Draft Amendment C256ball

Referral 15 – Ballarat North Precinct Structure Plan, Development Contributions Plan and Native Vegetation Precinct Plan

VPA Projects Standing Advisory Committee Report

9 June 2026

Figure 7 Day 1 PSP Plan 6 Water

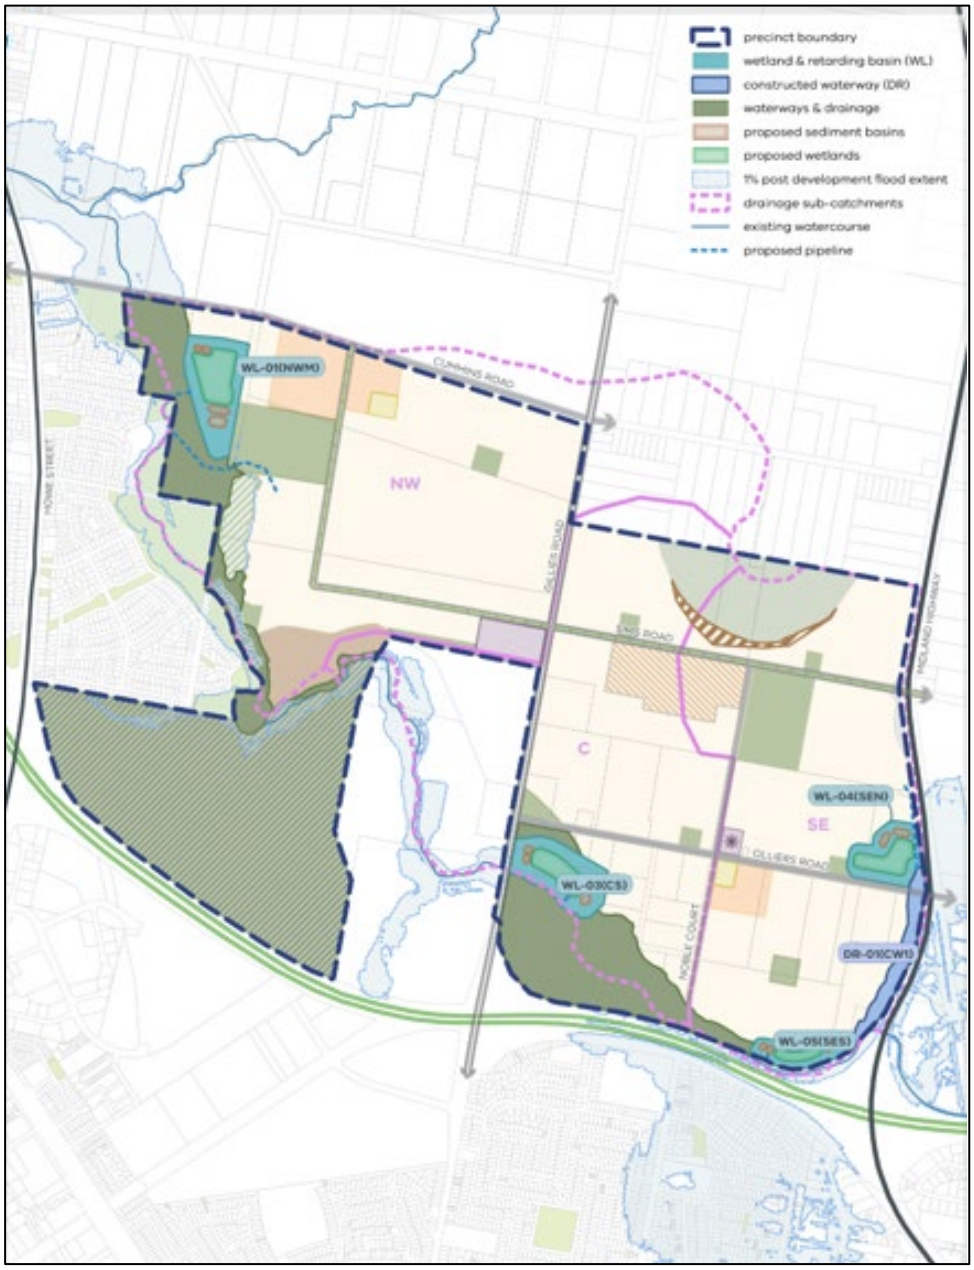
- the redundant pipeline shown on the Day 1 Plan 6 surrounding the WL-01 asset should be removed, as should the redundant pipeline shown on the Day 1 Plan 6 upstream of WL-04 adjacent to the Midland Highway (see Figure 7 above)

Figure 8 Beardshaw WL-01 proposal

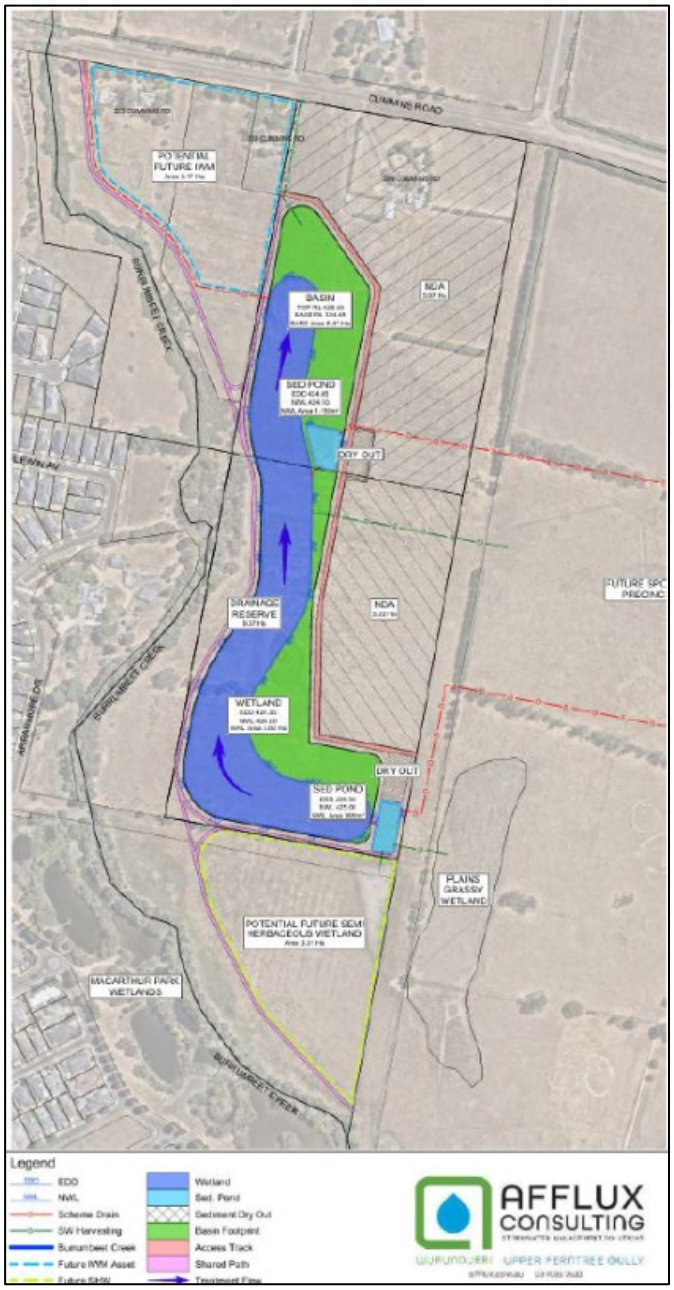
Mr Beardshaw agreed with the Day 1 resizing of WL-01 but considered it should be moved further within the floodplain, enabling land savings and providing a more integrated asset within the local environment (see Figure 8 below). He was concerned that the Day 1 placement increased the extent of batters and the area of reserve required to be purchased. He considered the placement of WL-01 within the floodplain:

- Enabled better connectivity of the IWM components, treatment objectives and flood storage objectives
- improved storage within the floodplain as the asset sits below existing surface level
- reduced cost of the asset in both design and construction due to reduced complexity
- enabled other options such as placement of an IWM harvesting lake to the north of the proposed wetland and potential further stormwater harvesting areas.

Figure 14 RD-02-1 and RD-02-2

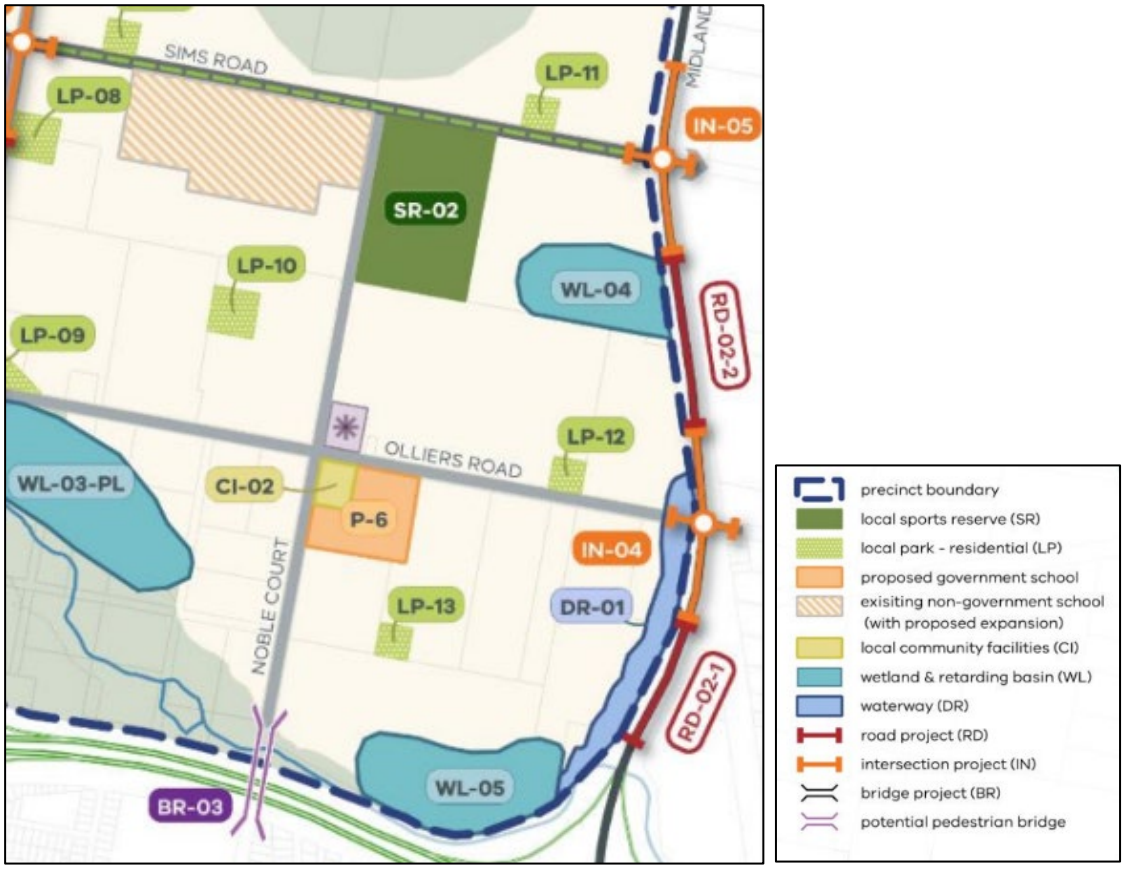
There is no strategic case for including the duplication of Midland Highway (RD-02-1 or RD-02-2) as DCP-funded projects in the Ballarat North Precinct Structure Plan. The 'agent of change' and 'but for' arguments, including those grounded in current State budget constraints, do not provide a sound or principled basis to transfer responsibility for duplicating an existing State arterial road to this PSP or to its DCP.

RD-02-1 and RD-02-2 (see Figure 14) are proposed duplication projects on the Midland Highway along the eastern edge of the PSP, together providing a continuous four-lane divided carriageway along the PSP frontage. Specifically:

d) Delete all references to road projects RD-02-1 and RD-02-2 (Midland Highway duplication).
e) Show Midland Highway as a single carriageway arterial road.

f) Note that any future duplication of the Midland Highway within or adjacent to the Precinct is a matter for State planning and funding processes and is not to be delivered or funded through this Precinct Structure Plan.

Figure 18 Excerpt of plan showing schematic designs for IN-04 and IN-05

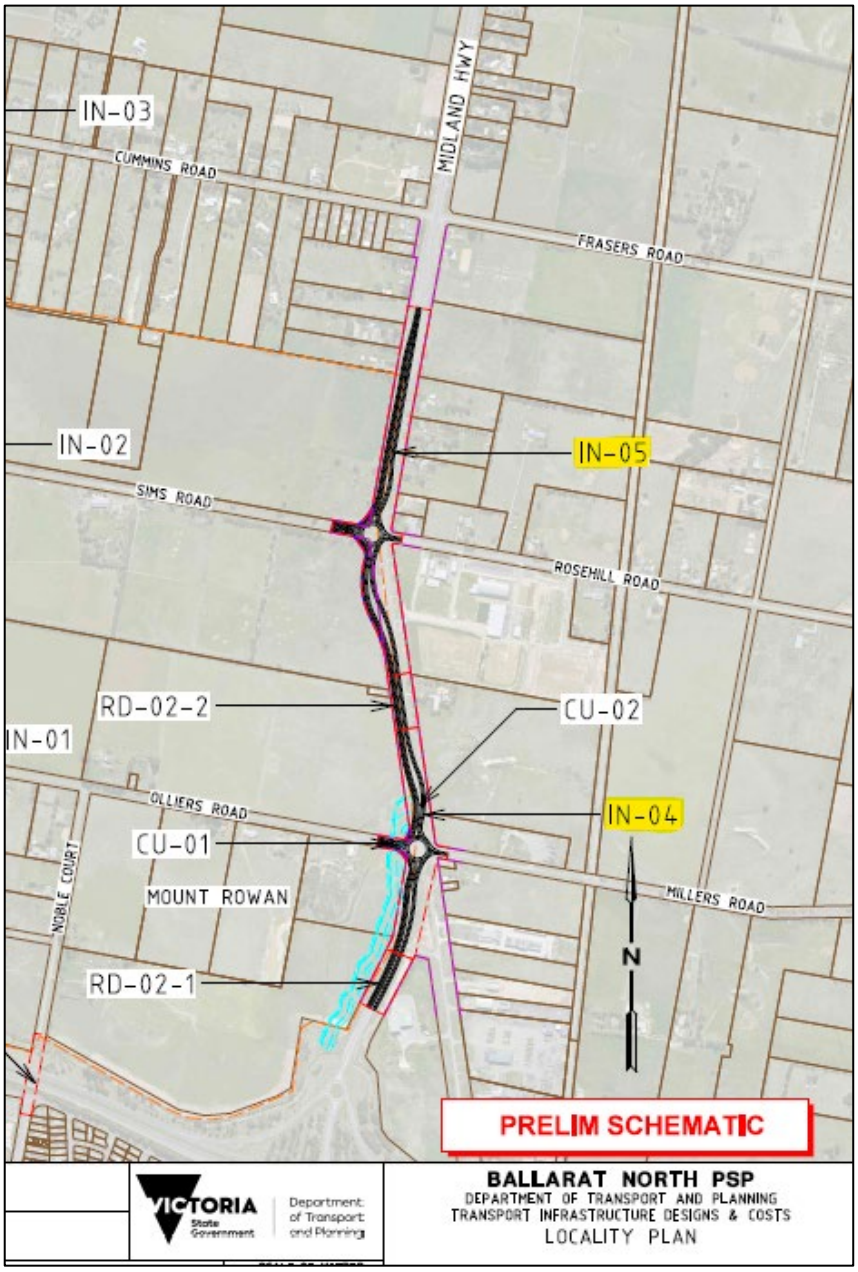
The proposed roundabout treatments for IN-04 and IN-05 have not been strategically justified and should be replaced by traffic signal treatments (as shown in the exhibited Precinct Structure Plan and Development Contributions Plan). The traffic treatments at IN-04 and IN-05 should be redesigned to meet the basic and essential criteria for works associated with the Precinct Structure Plan and to satisfy the principles of need and nexus for inclusion in the Development Contributions Plan. The redesigned treatments should be limited to a basic and essential standard and contained within the existing Midland Highway reservation.

- a four lane duplication of the Midland Highway was anticipated, and intersection design should align with this ultimate configuration
- although SIDRA modelling suggested a three lane roundabout could achieve a comparable level of service, it was expected to create bottlenecks and increased congestion.

Accordingly, SMEC was instructed to develop designs based on an ultimate four lane roundabout arrangement. See Figure 19.

g) Show intersection projects IN-04, IN-04c (Midland Highway/Olliers Road) and IN-05 and IN-05c (Midland Highway/Sims Road) as signalised cross-intersections as the ultimate form of treatment and identify these intersections should be designed to a basic and essential standard and accommodated within the existing Midland Highway reservation.

Figure 15 Cummins Road upgrade (RD-03-1) and Burrumbeet Creek culvert (CU-03)

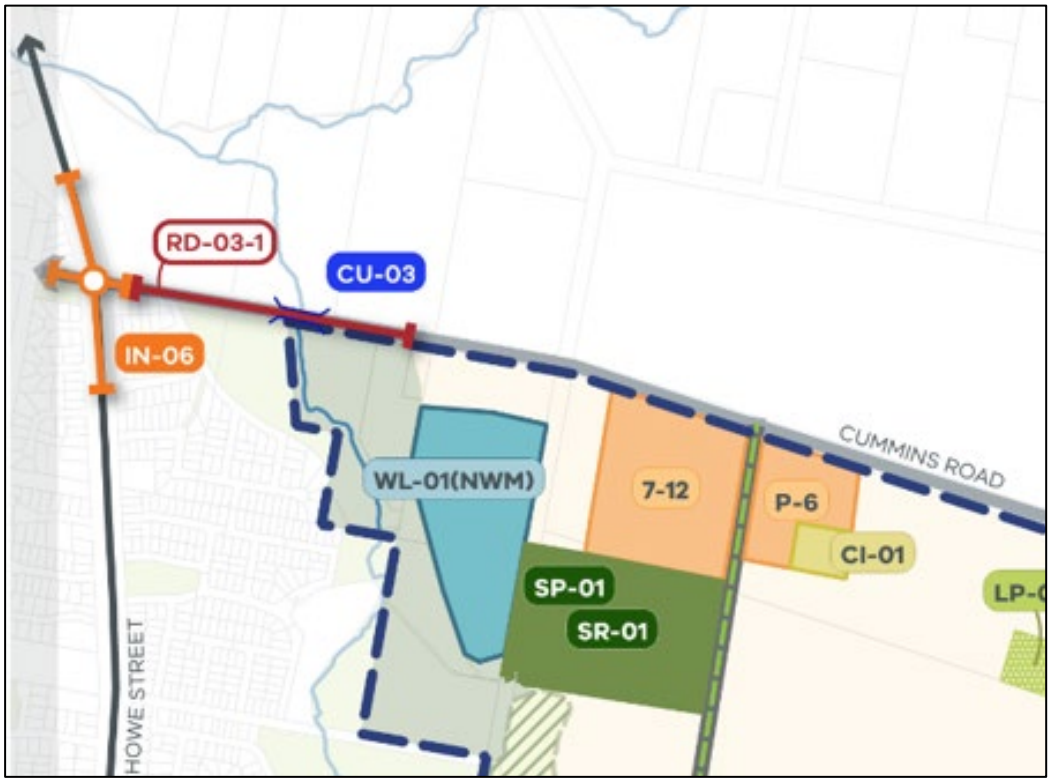
- the only works required to improve RD-03-1 were eastbound bicycle provisions as either an on-street bicycle lane or a shared path
- the western end of Cummins Road should not be raised and reconstructed as it was a relatively new road, constructed around 2020 (see Figure 16).

Figure 17 BR-03

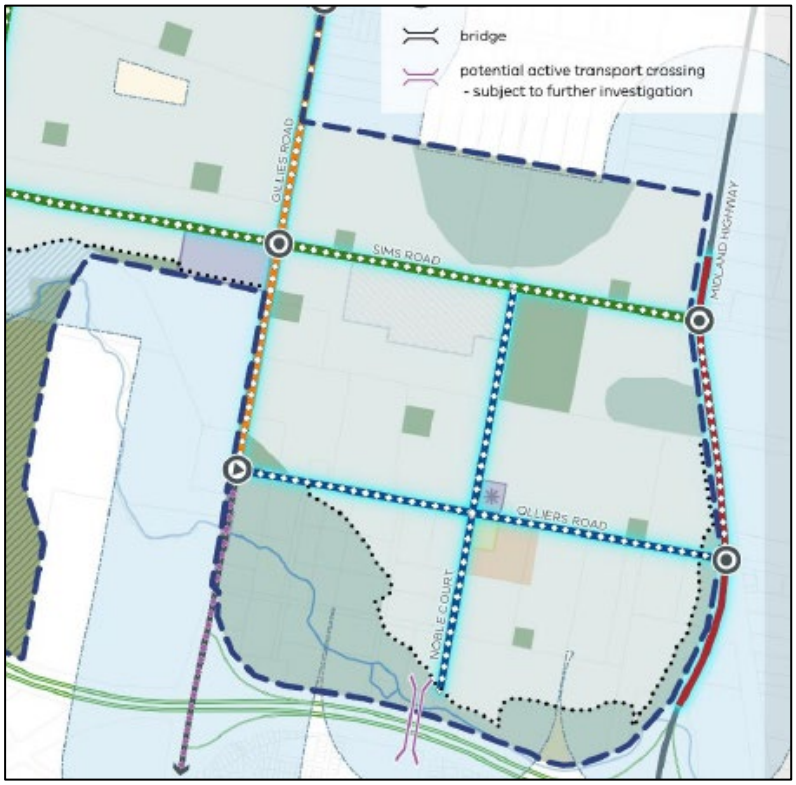
The proposed pedestrian and cycling bridge over the Western Freeway (BR-03) is not basic and essential infrastructure for the purposes of the DCP and is not required to achieve the PSP's core land use and movement objectives within the life of this DCP. Two alternatives to provide active transport links over the Western Freeway already exist: existing bridges on Gillies Road and Midland Highway.

BR-03 is a proposed active transport bridge over the Western Freeway connecting the PSP to the Forest Street Strategic Cycling Corridor in established Ballarat (refer Figure 17).

h) Update Table 19 to include a notation that bridge project BR-03 is subject to further investigation, design and costing.
i) Relocate the southeast P-6 proposed government school and community facility CI-02 from the south-east corner of Olliers Road and Noble Court onto land parcel 57 on the north-west corner of that intersection and update all consequential plans, tables and provisions

Figure 18 Exhibited PSP Plan 8 Community infrastructure

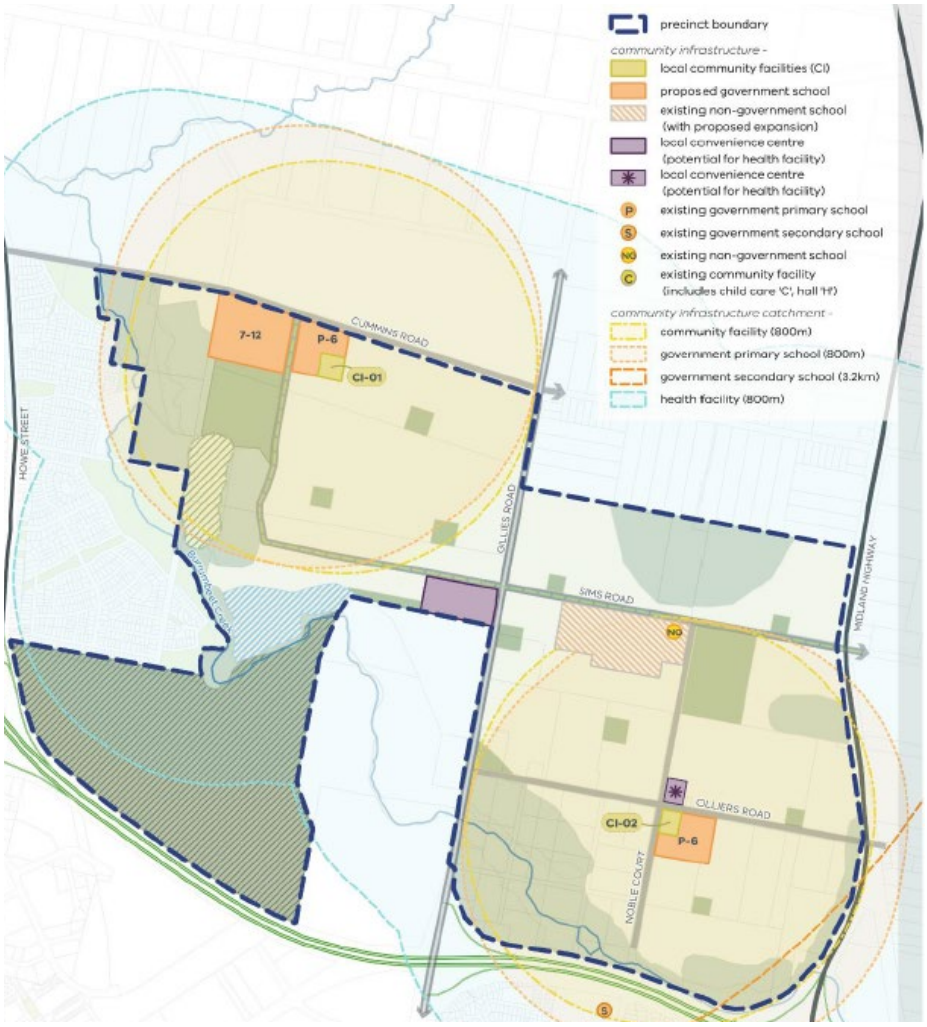
The southeast P-6 school is currently shown on the south-east corner of Olliers Road and Noble Court, co-located with a local community facility CI-02 and opposite a local convenience centre on the north-east corner as shown in Figure 18.

Figure 20 Day 1 PSP Plan 10 Infrastructure and Staging Plan

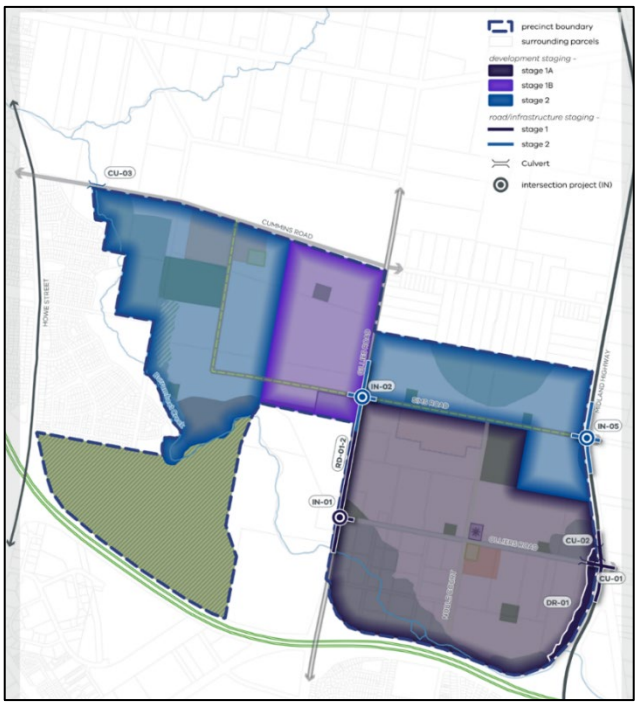
The PSP includes an Infrastructure Development Staging Plan (Plan 10) (refer Figure 20) that identifies two broad stages of development across the precinct. Stage 1 comprises land in the south-east of the precinct, abutting Gillies Road, Sims Road and the Midland Highway, being the area containing key transport and drainage infrastructure considered necessary to service the wider precinct. Stage 2 comprises the remaining areas in the northern and western portions of the precinct.

j) Remove the Infrastructure Development Staging Plan (Plan 10), all staging guidelines and revise Table 19 from the Precinct Structure Plan, together with any consequential references to remove staging for infrastructure delivery in the Precinct Structure Plan documentation.

Figure 21 Extract of Final Day PSP Plan 2 (Place Based Plan) showing the Expanded Area

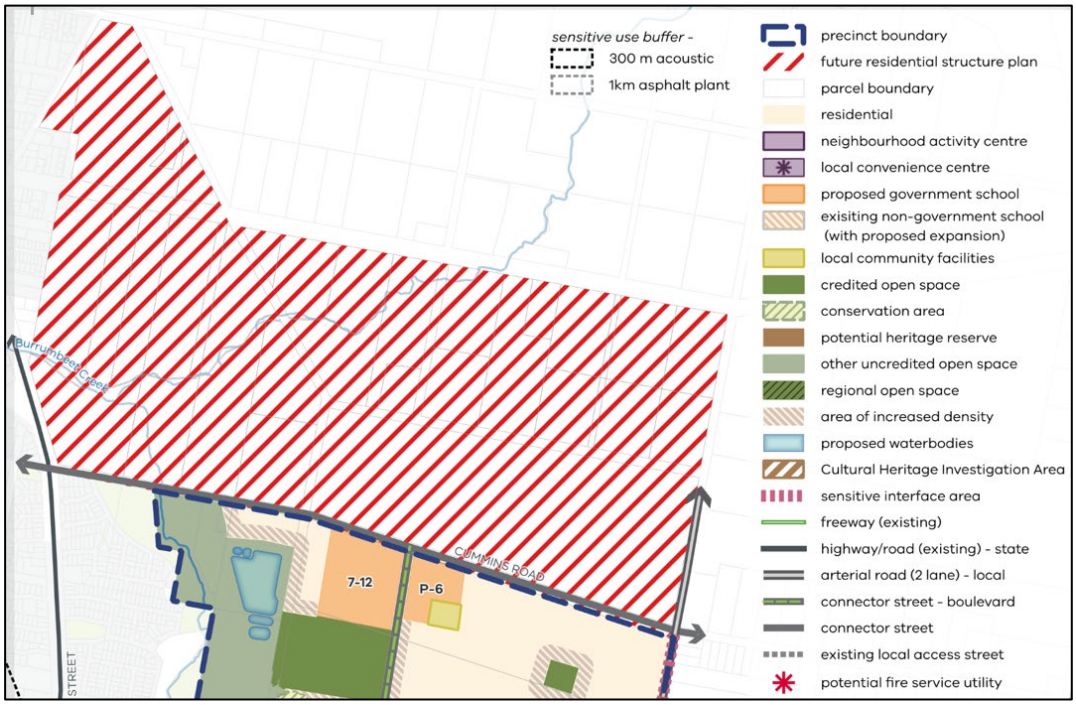
The expanded area sits outside the current PSP boundary but underpins infrastructure scope, apportionment and timing within it. The planning framework should reflect this, and the Committee recommends targeted amendments to Clause 11.02-2L and the Ballarat North Expanded Area Map to provide the necessary transparency and certainty.

The expanded area is the land north of Cummins Road, identified in the exhibited PSP on Plan 2 (refer to Figure 21) as a red hatched area noted as 'future residential structure plan – Expansion Area' and in the Framework Plan as the 'Ballarat North Expanded Area'. It falls outside the current PSP boundary.

b) replace the North Expanded Area Map with the map as it appears in Tabled Document 89(b).
